REMARKS/ARGUMENTS:

Claims 9 and 20: PTO rejected claims 9 and 20 as being anticipated by Allison (4,065,225), stating that “Allison discloses a co-axial multi-rotor wind turbine having a counterweight 12 forward of a pivot point serving to at least partially counterbalance a downwind section of the driveshaft 32 and its attached rotors.”

Left: Applicant's actual prototype, funded by the California Energy Commission, with brake, generator, dedicated counterweights, and massive parts of the support frame located upwind of a central pivot, counterbalancing the downwind section of the driveshaft and its attached rotors.

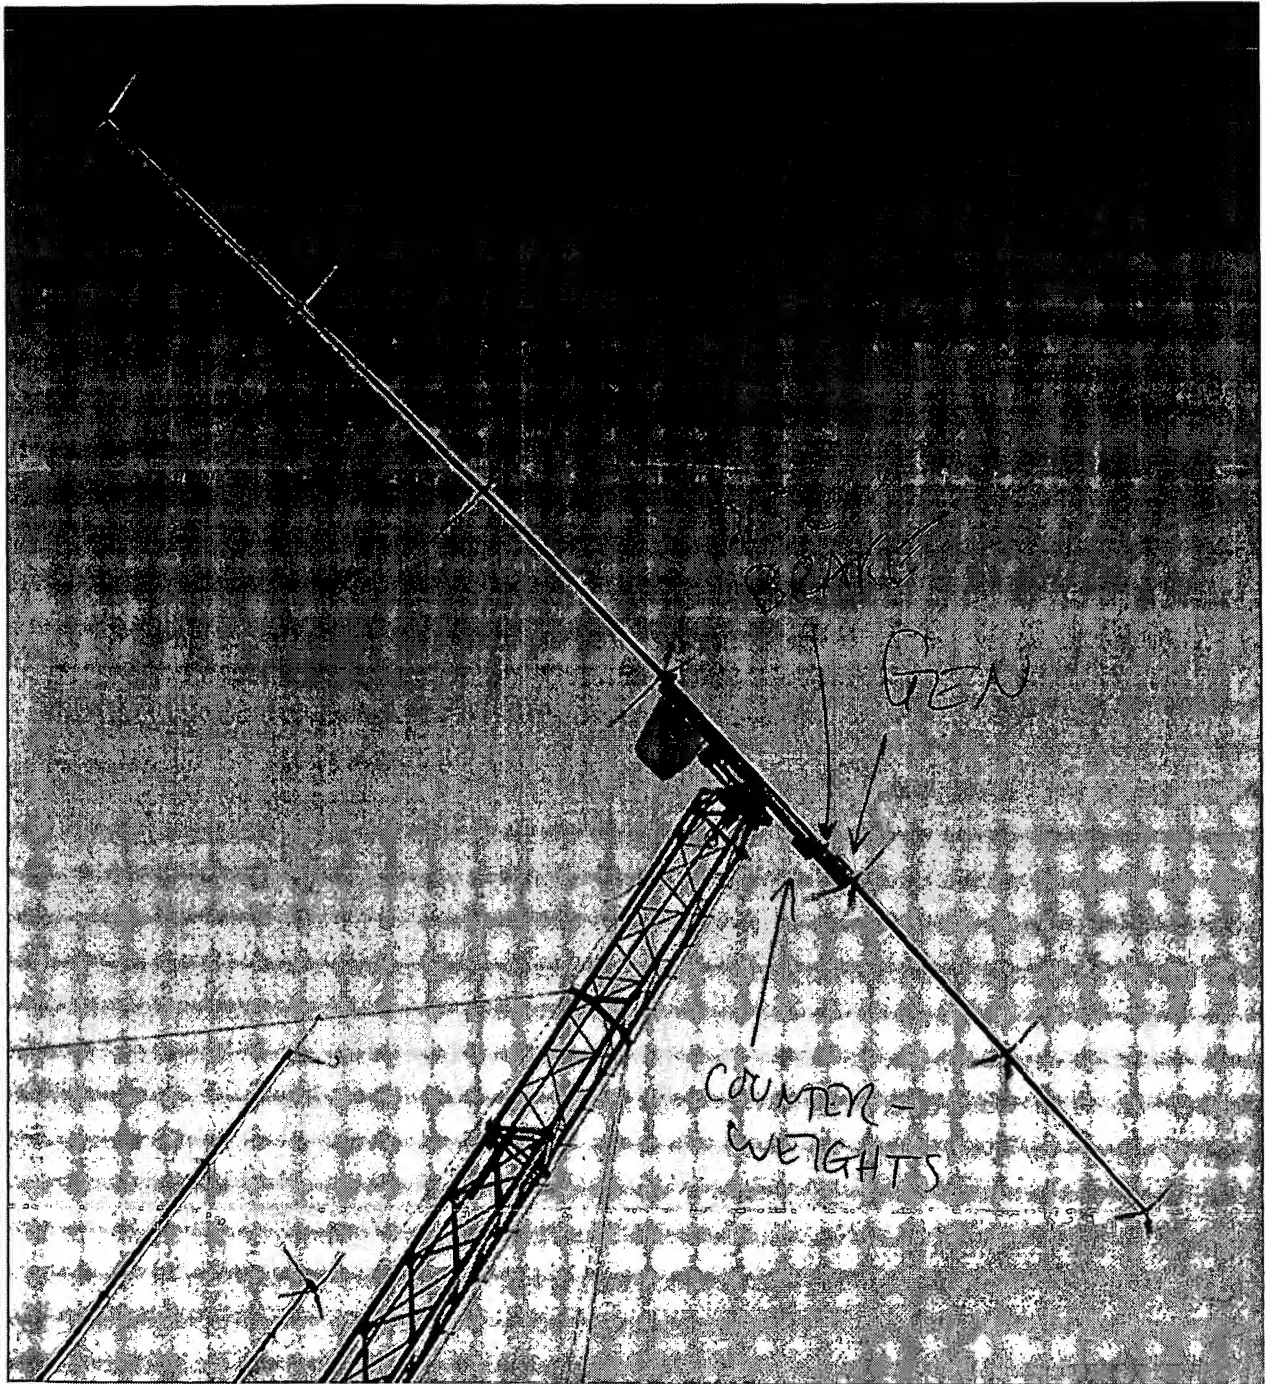
- Applicant has therefore amended claims 9 and 20, adding the modifying phrase "at least part of said counterweight not co-rotating with said turbine" to claim 9 and adding the word "non-rotating" to describe the massive components of claim 20, to distinguish over Allison and over Applicant's own prior art patents mentioned above.
